Planning Commission Agenda

Tuesday, December 17, 2024 at 7:00 PM
27400 Southfield Road, Lathrup Village, Michigan 48076

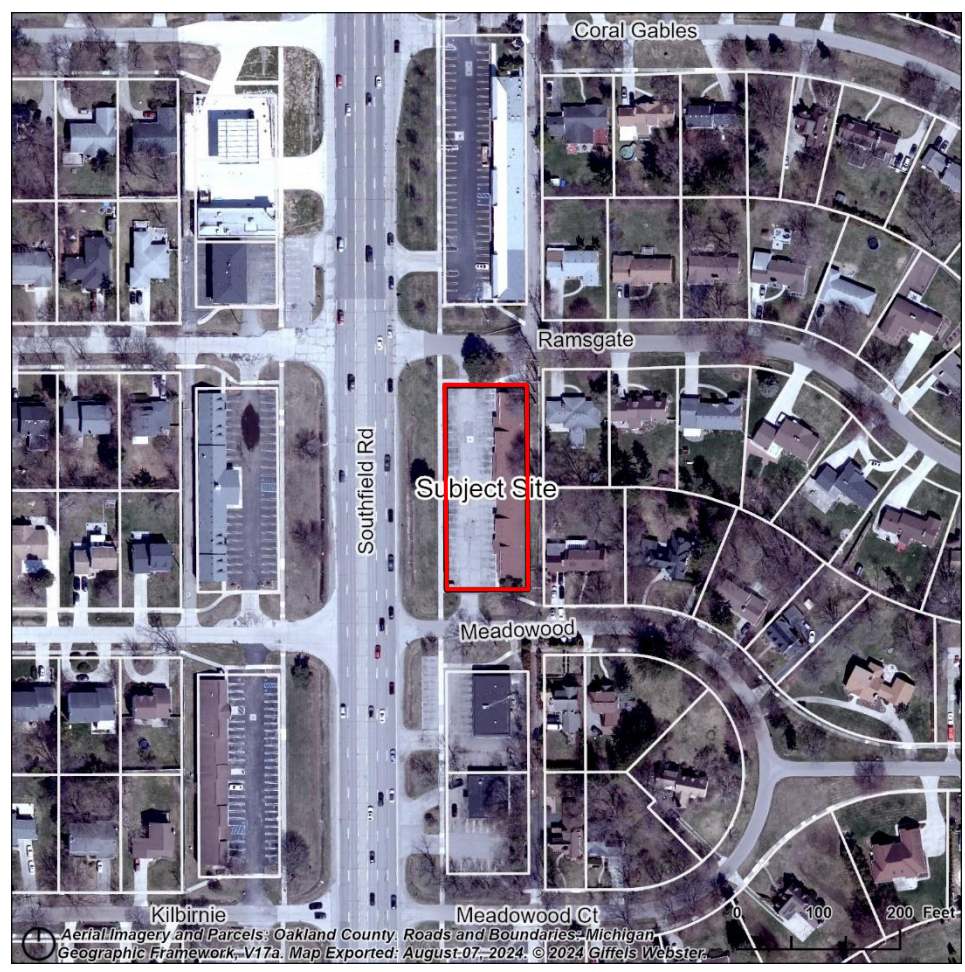
Site Plan Review

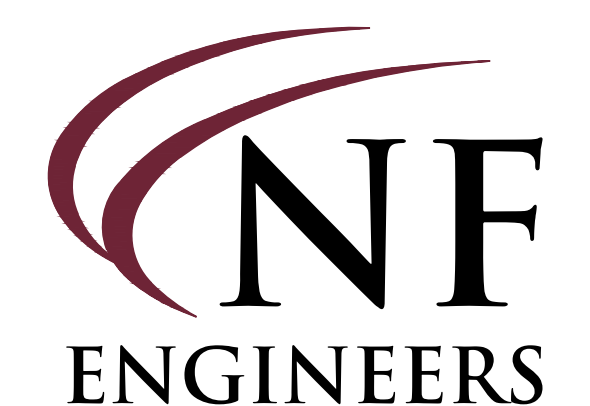
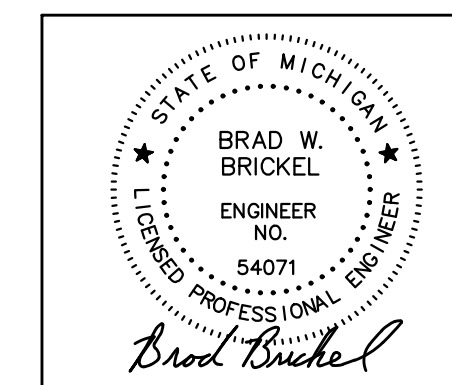
REVISIONS:
10-17-24 ISSUED FOR SITE PLAN REVIEW

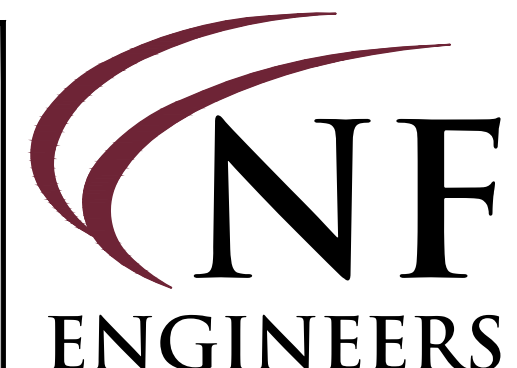
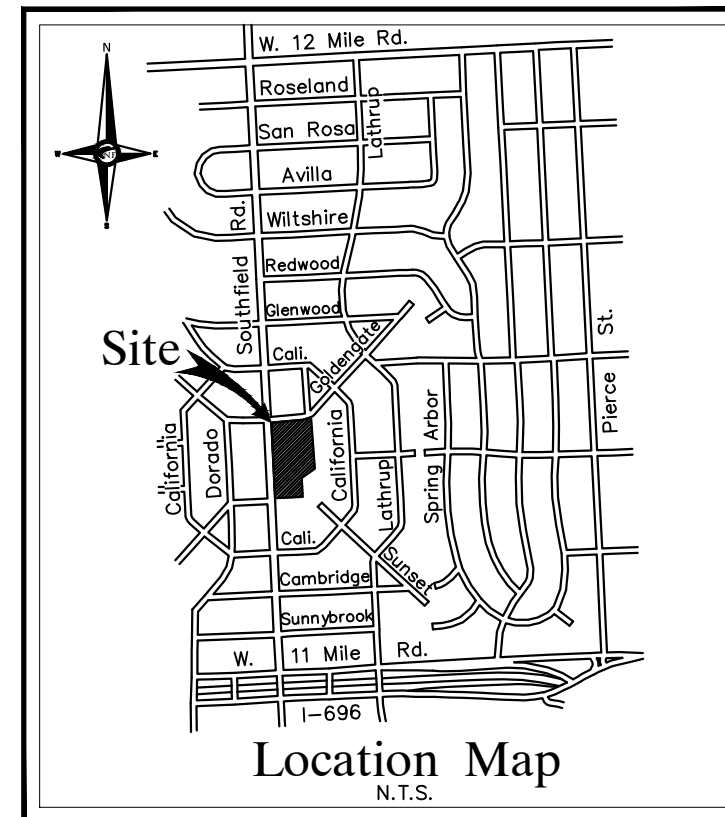
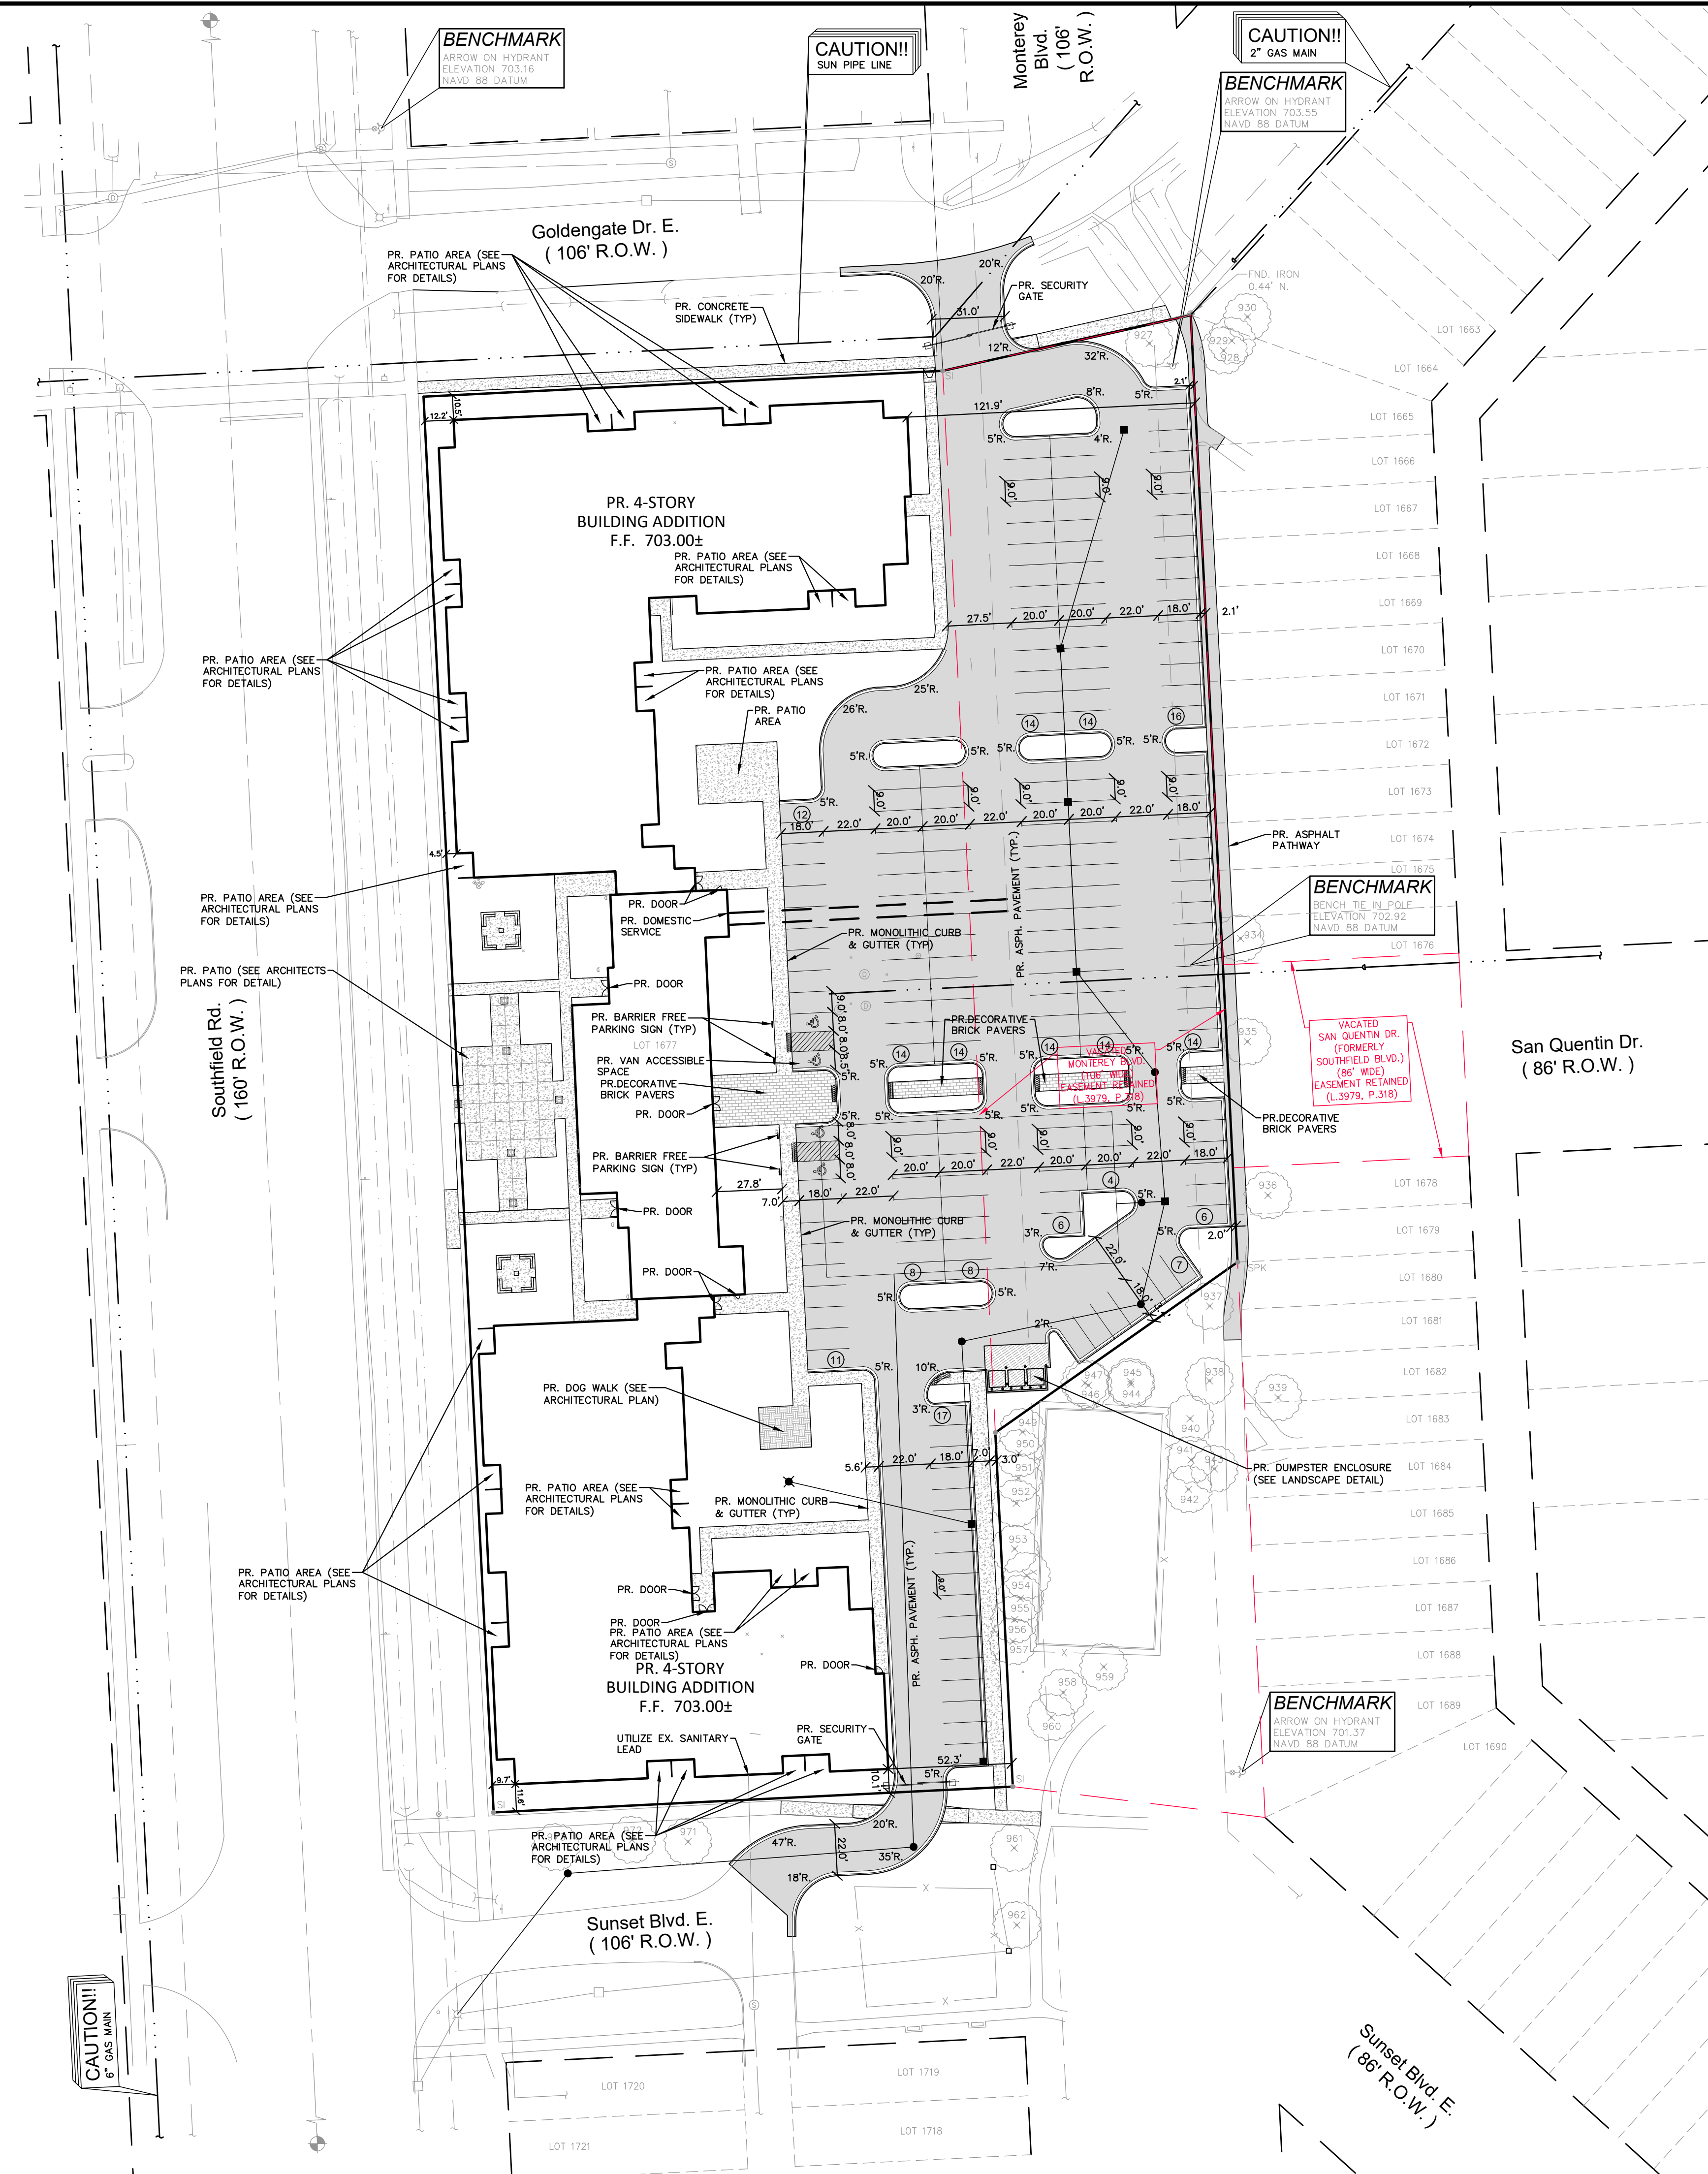
DATE ISSUED/REVISED
10-17-24 ISSUED FOR SITE PLAN REVIEW

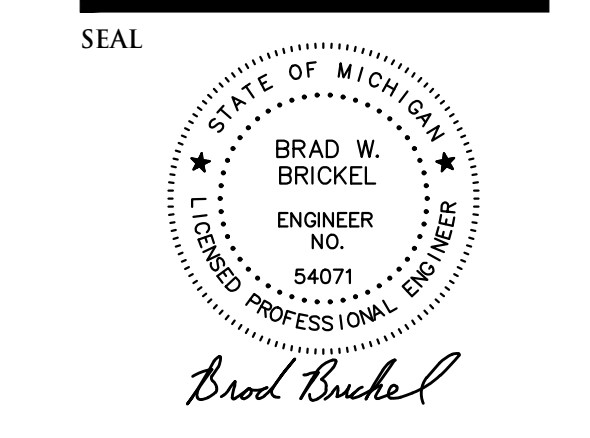
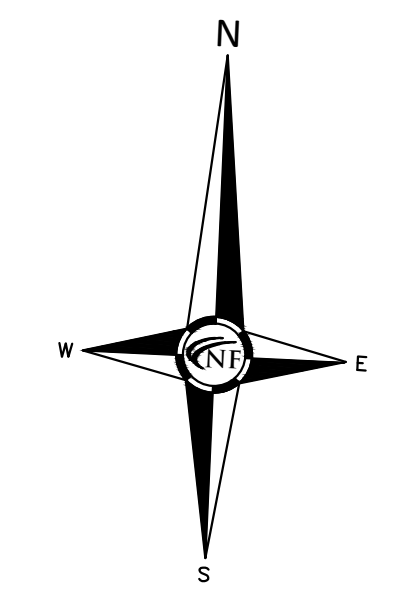
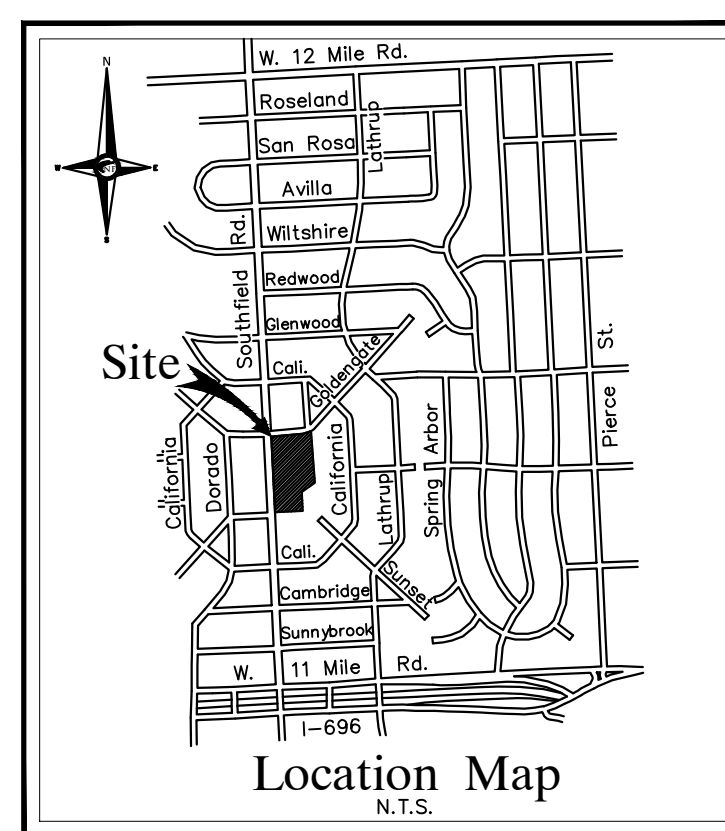
DATE ISSUED/REVISED
10-17-24 ISSUED FOR SITE PLAN REVIEW

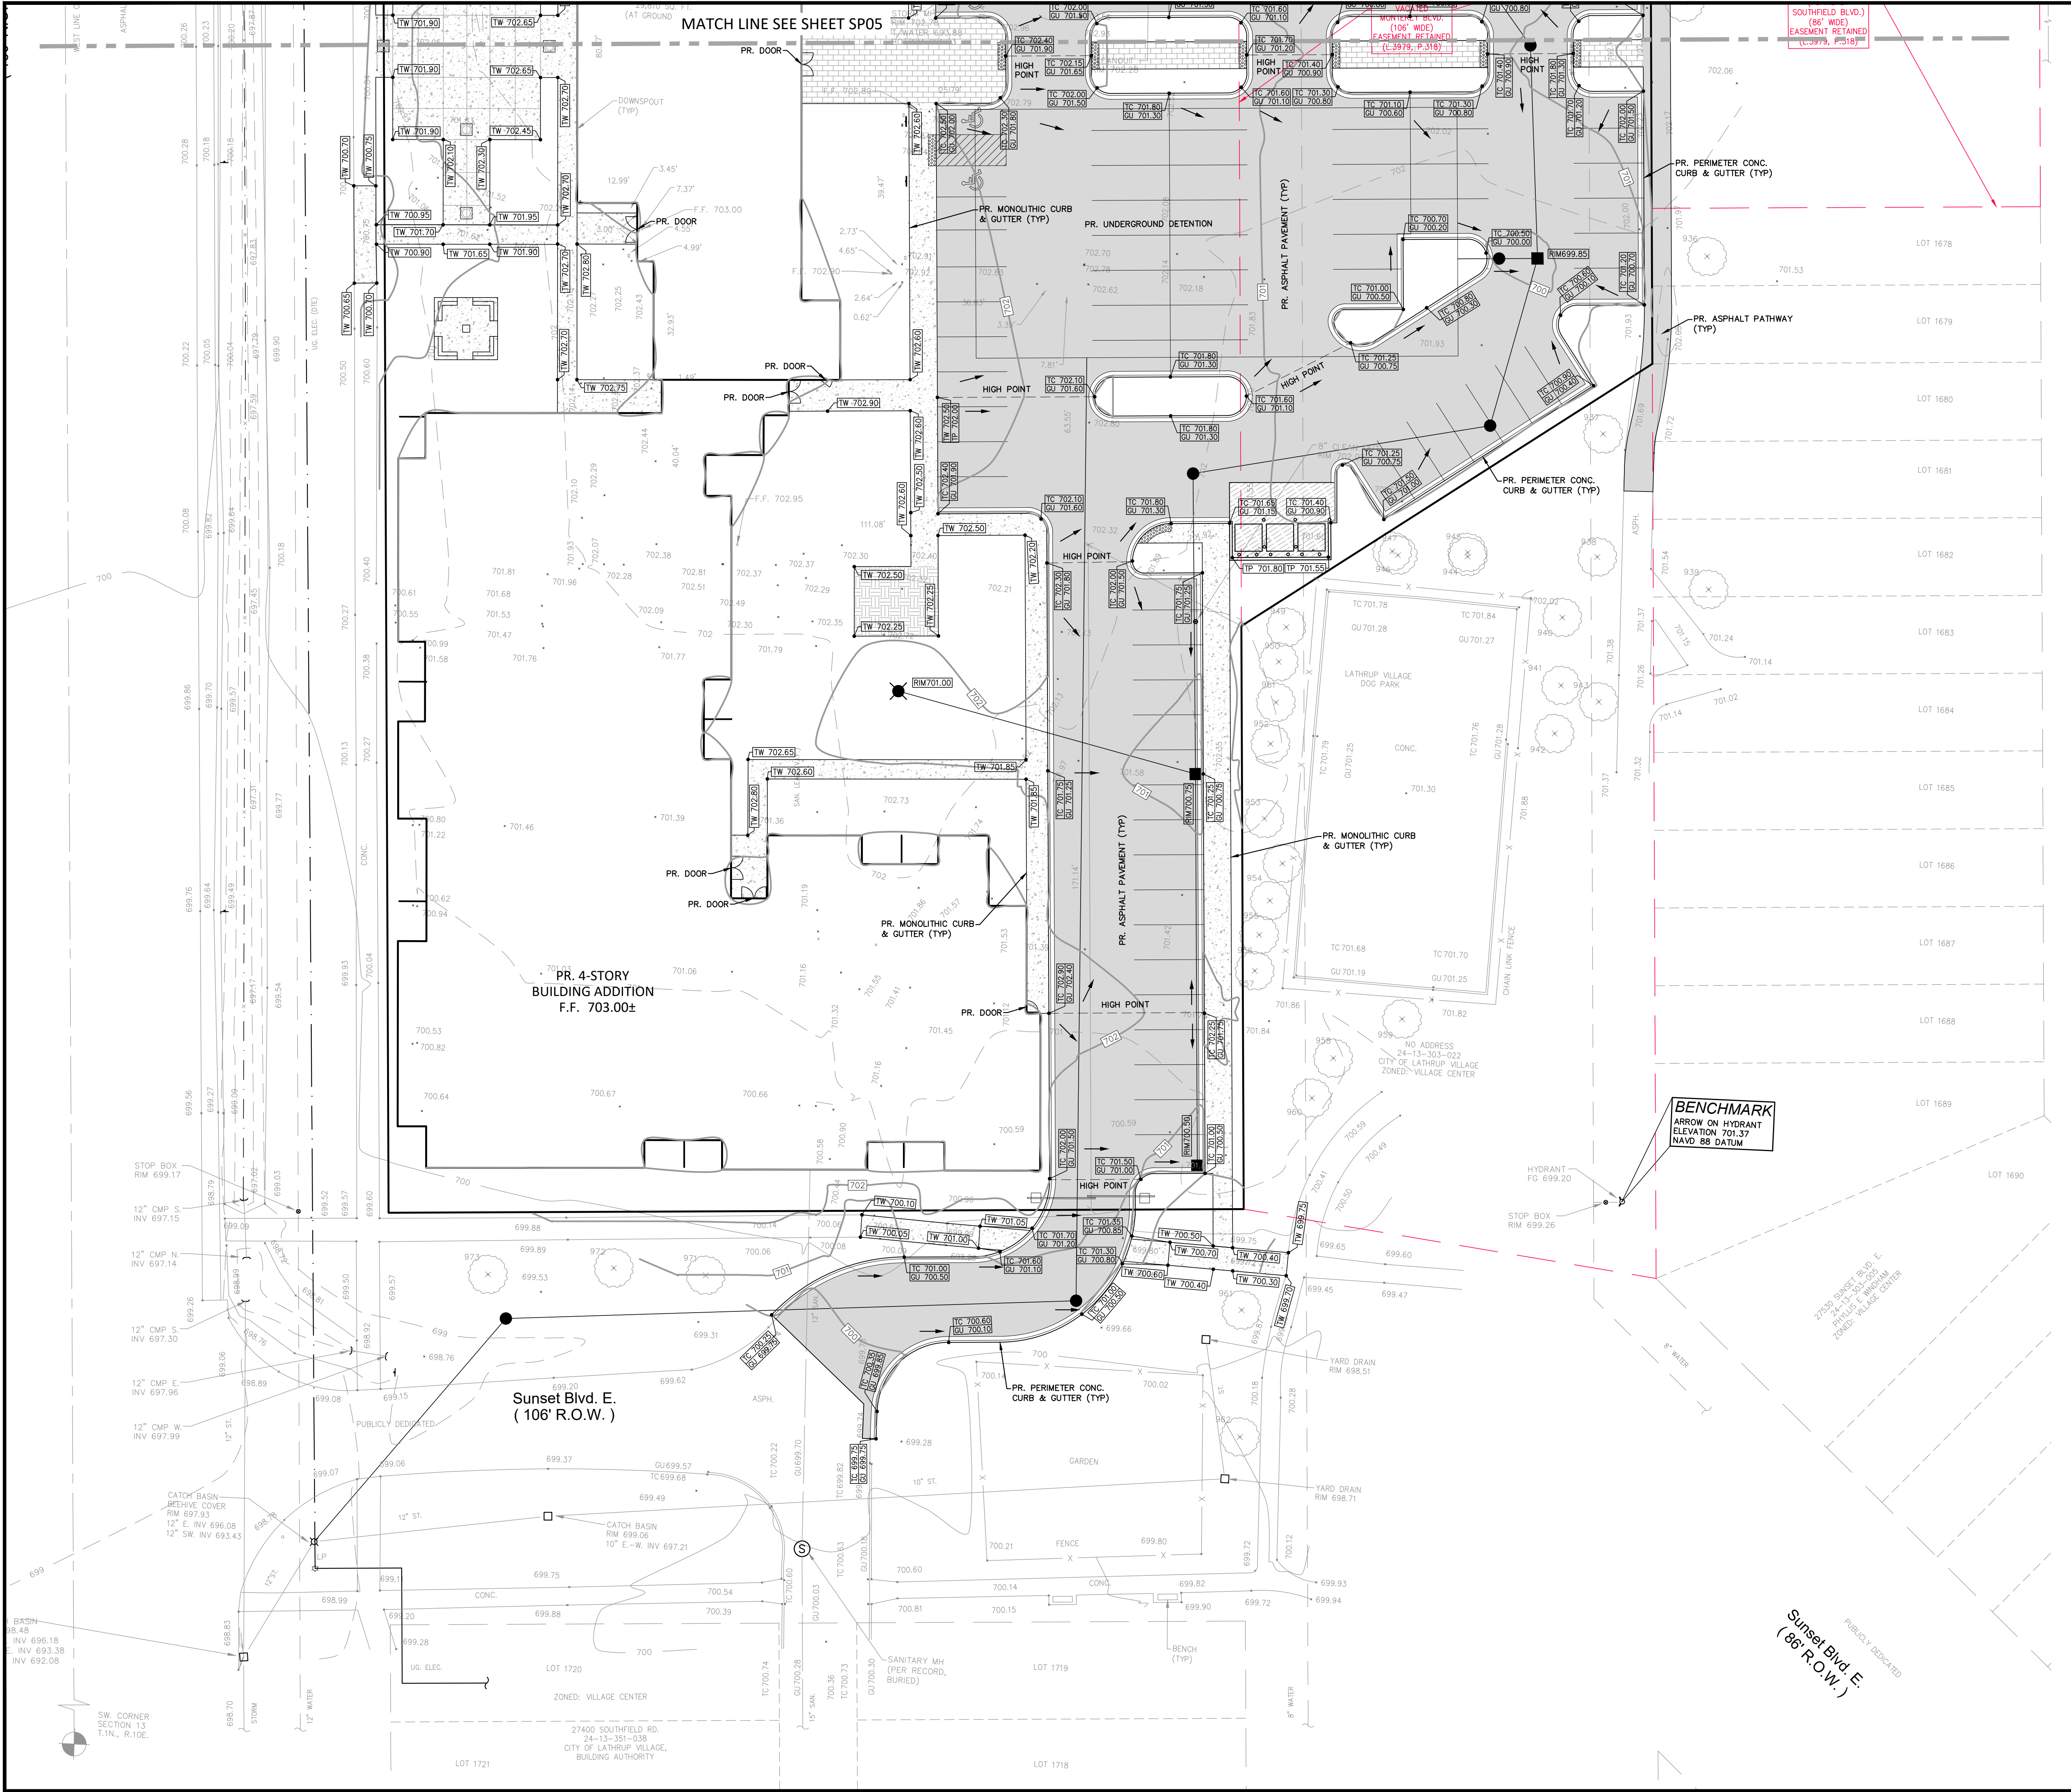
DATE ISSUED/REVISED
10-17-24 ISSUED FOR SITE PLAN REVIEW
